Memorandum to the City of Markham Committee of Adjustment

File: A/128/21

Address: 8 Jonquil Crescent – Markham, ON

The following comments are provided on behalf of the East District team. The applicant is requesting relief from the following "Residential One - (R1)" zone requirements under Bylaw 1229, as amended, as they relate to a new two-storey detached dwelling. The variances requested are to permit:

Elevations & Roof Plan

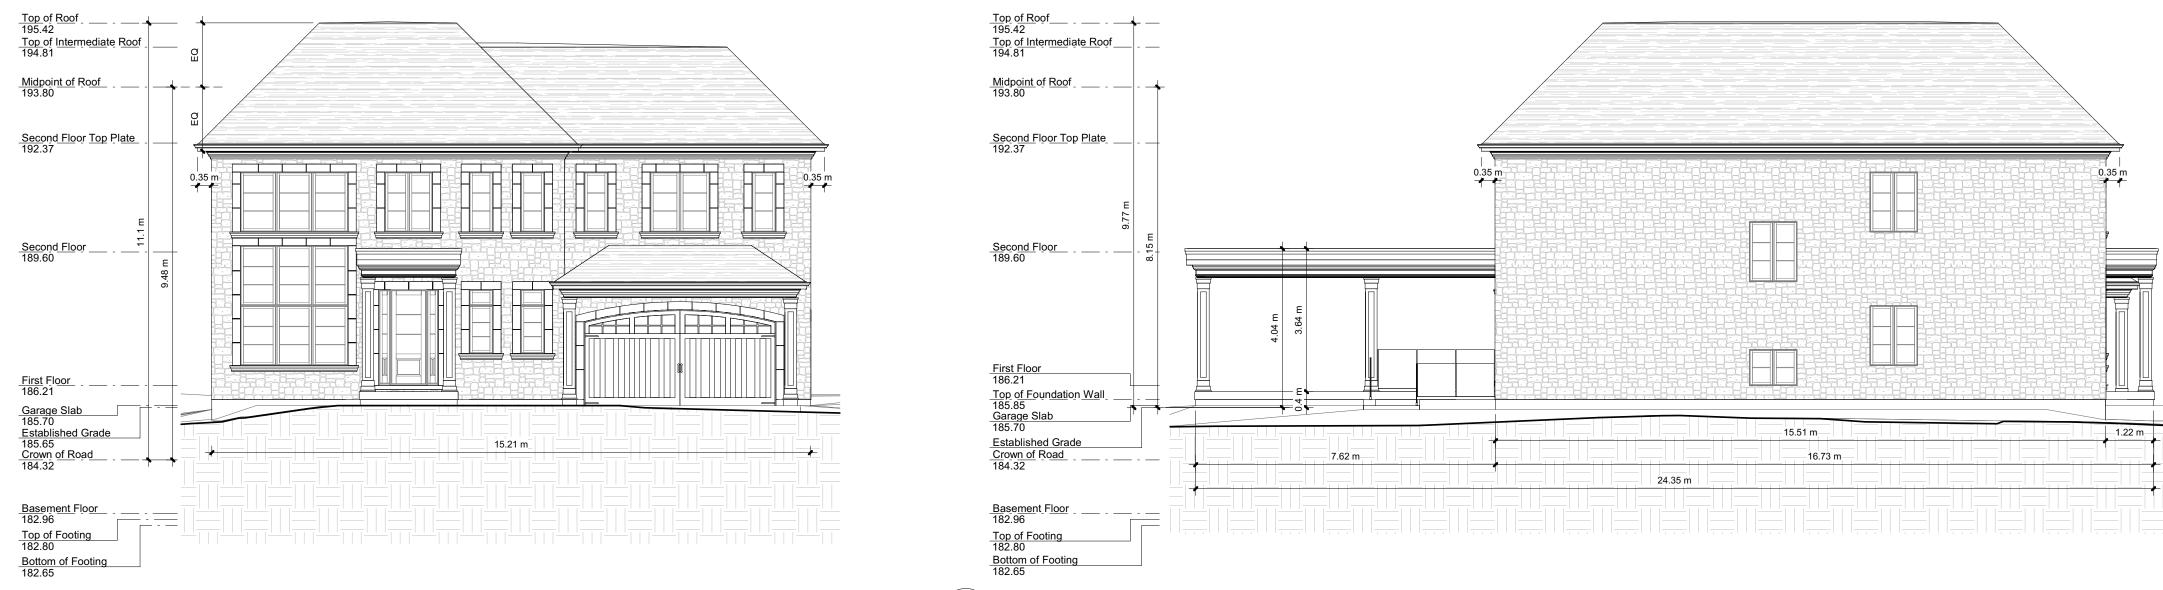
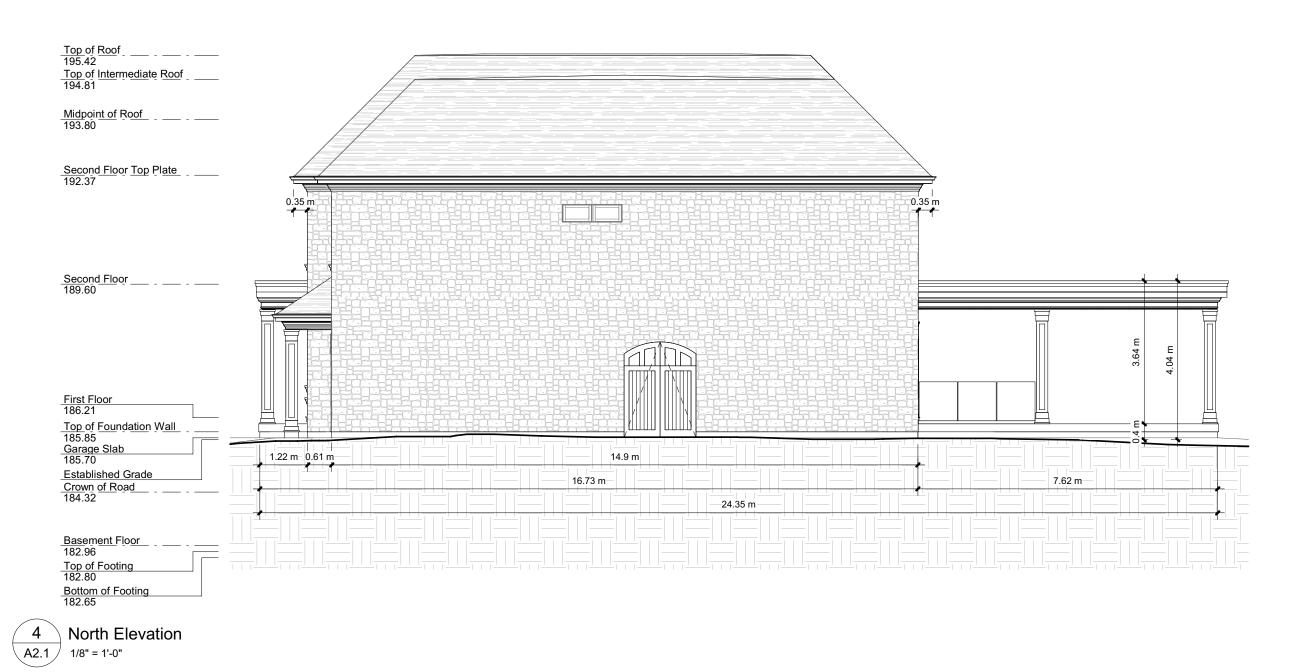
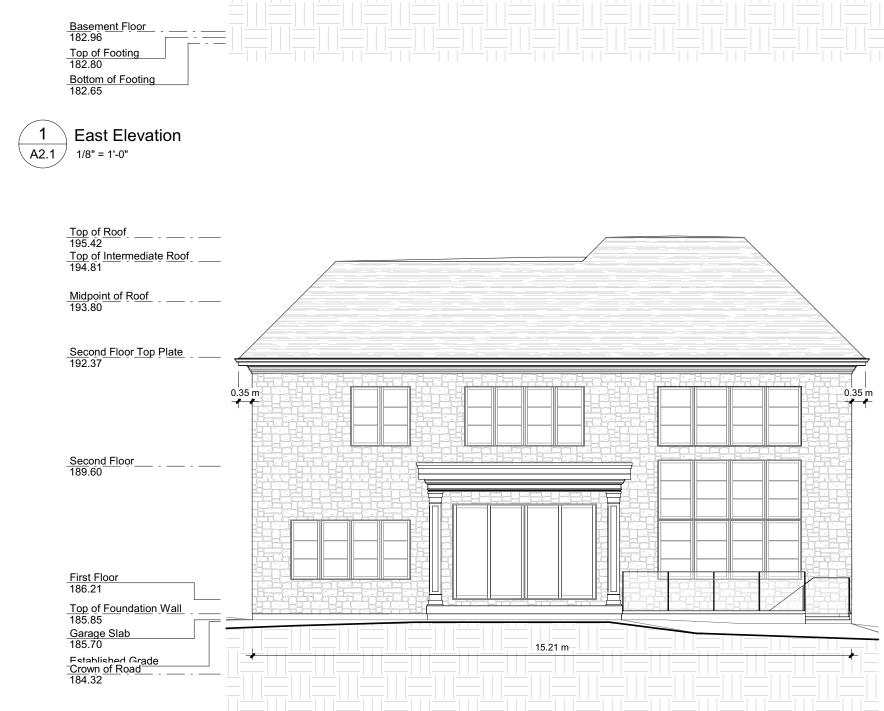
The applicant is requesting relief to permit a maximum building height of 11.10 m (36.42 ft), whereas the By-law permits a maximum building height of 9.80 m (32.15 ft). This is an increase of 1.30 m (4.27 ft).

The By-law calculates building height using the vertical distance of building or structure measured between the level of the crown of the street and the highest point of the ridge of a gable, hip, gambrel or other type of pitched roof.

Measured from the crown of the road: the top of roof has a height of 11.10 m (36.42 ft), which does not span across the entire roofline; stepped down, the lower ridge of the roof has a height of 10.49 m (34.41 ft). Staff have given consideration to the grade at the front of the house, which is approximately 1.36 m (4.46 ft) above the crown of the street at the mid-point, the balance of which the applicant is seeking relief to permit an increase in height. Therefore, the height of the building from grade at the mid-point of the property to the high point of the roof is approximately 9.77 m (32.05 ft). Staff are of the opinion that the variance maintains the general intent of the By-law, is an appropriate development for the lot, and is minor in nature.
